**Re: Lot 17 Block 9 Unit 22 Volcano Cliffs, S.A.D. 228
6427 Petirrojo Rd. NW
Request Permanent C.O. – Accepted
Engineer's Stamp dated: 1-2-18 (D10D003Q17)
Certification dated: 11/7/18**

RE: **Lot 17 Block 9 Unit 22, S.A.D. 228**
Volcano Cliffs Subdivision
6427 Petirrojo Rd. NW
Grading and Drainage Plan
Engineers Stamp Date; 1-2-18 (D10D003Q17)
Pad Certification Date; 2/22/18

CITY OF ALBUQUERQUE, BERNALILLO COUNTY		NEW MEXICO	
LOT 17, BLOCK 9, UNIT 22 VOLCANO CLIFFS SUBDIVISION			
CANDELARIA - SPEC 2- 6427 PETIRROJO - GRADING & DRAINAGE PLAN			
McDowell Engineering, Inc.			
7820 BEVERLY HILLS AVE. NE • ALBUQUERQUE, NM 87122 TELE: 505-828-2430 • FAX: 505-821-4857			
Designed JSM	Drawn STAFF	Checked JSM	Sheet of
File CAN0517L	Date NOVEMBER, 2017		1 1

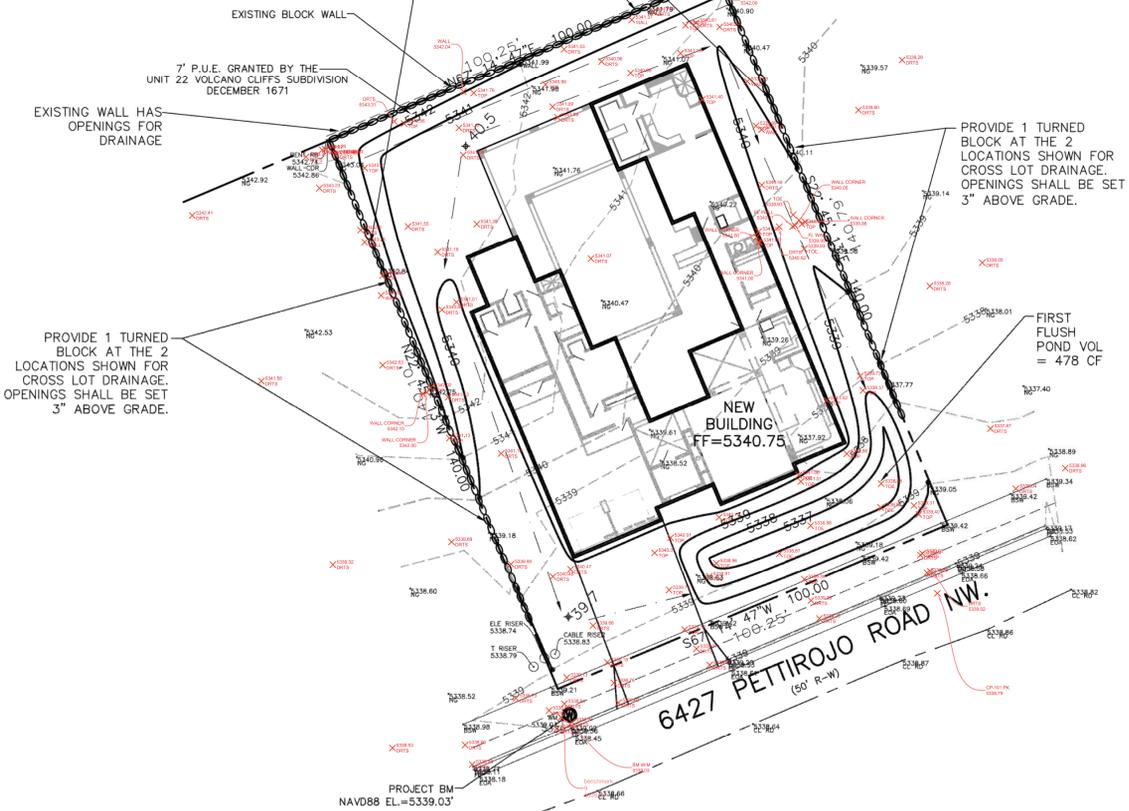
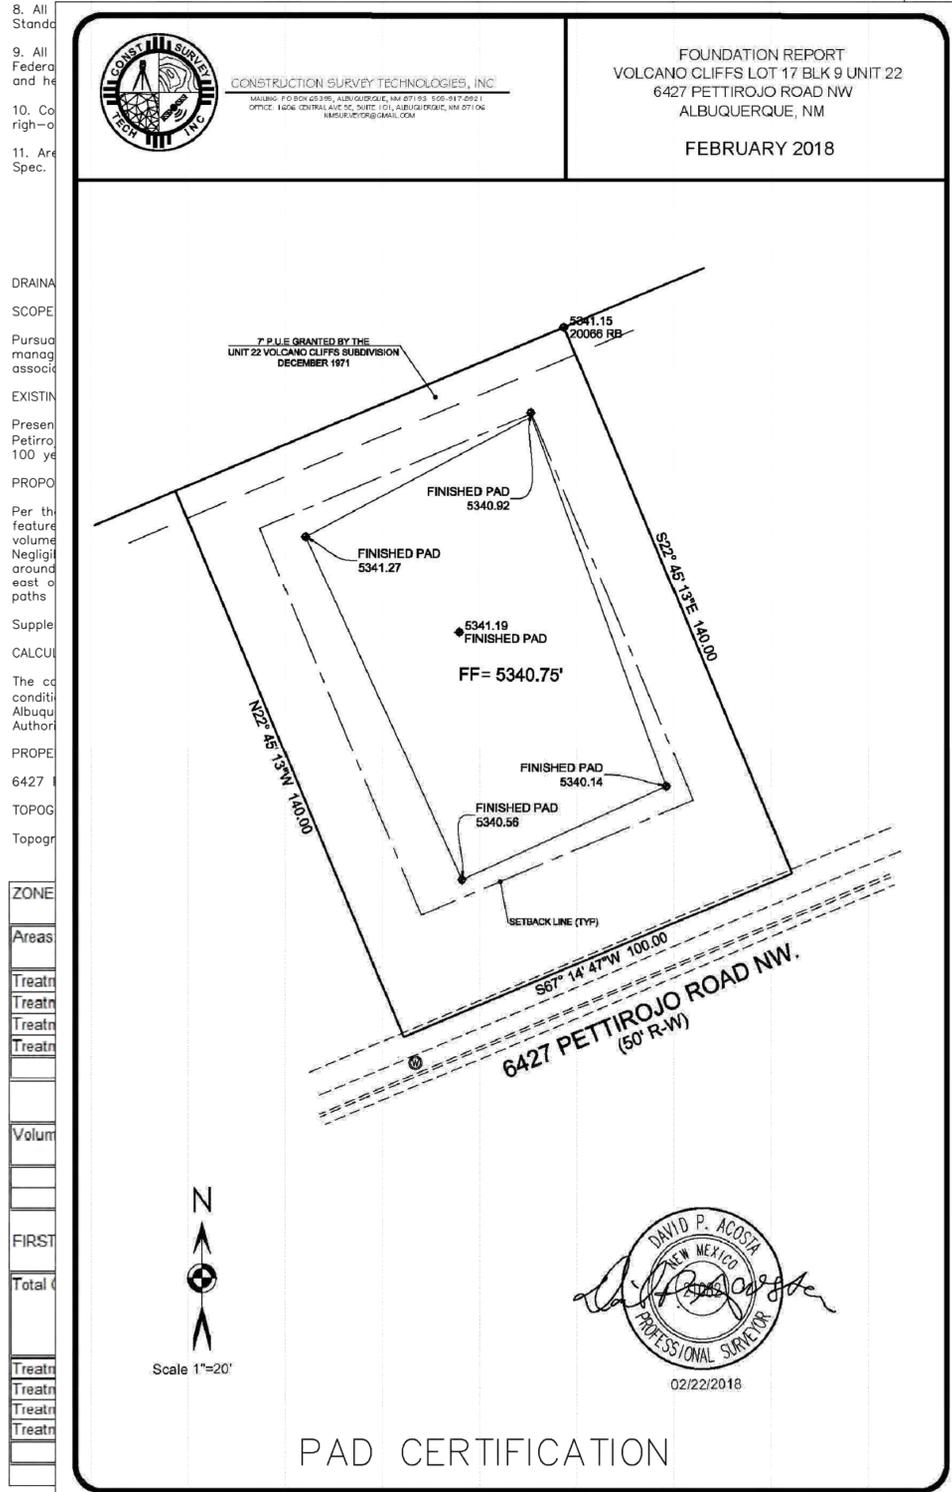
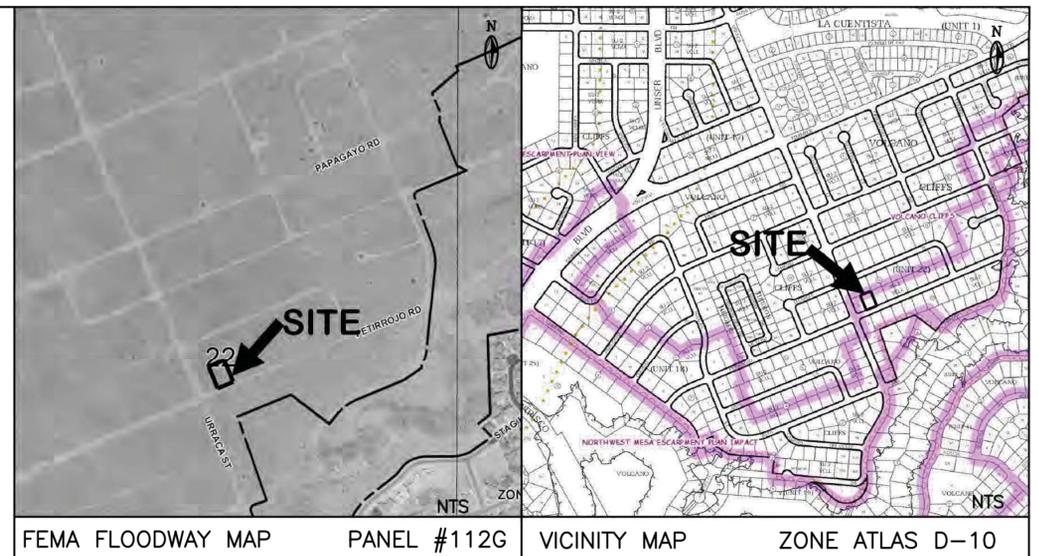
Albuquerque Based on the Certification received 11/8/2018, the site is acceptable for release of
Certificate of Occupancy by Hydrology.

Based upon the information provided in your submittal received 2/27/18, this plan is approved for Building Permit.

Please have the owner/builder attach a copy of this approved plan, to the construction sets in the permitting process prior to sign-off by Hydrology. Reiterate to the Owner/Contractor that a separate permit for a garden/retaining wall must be obtained, with the approved G&D plan dated 1/22/18.

Prior to Certificate of Occupancy release, Engineer Certification per the DPM checklist of this plan will be required.
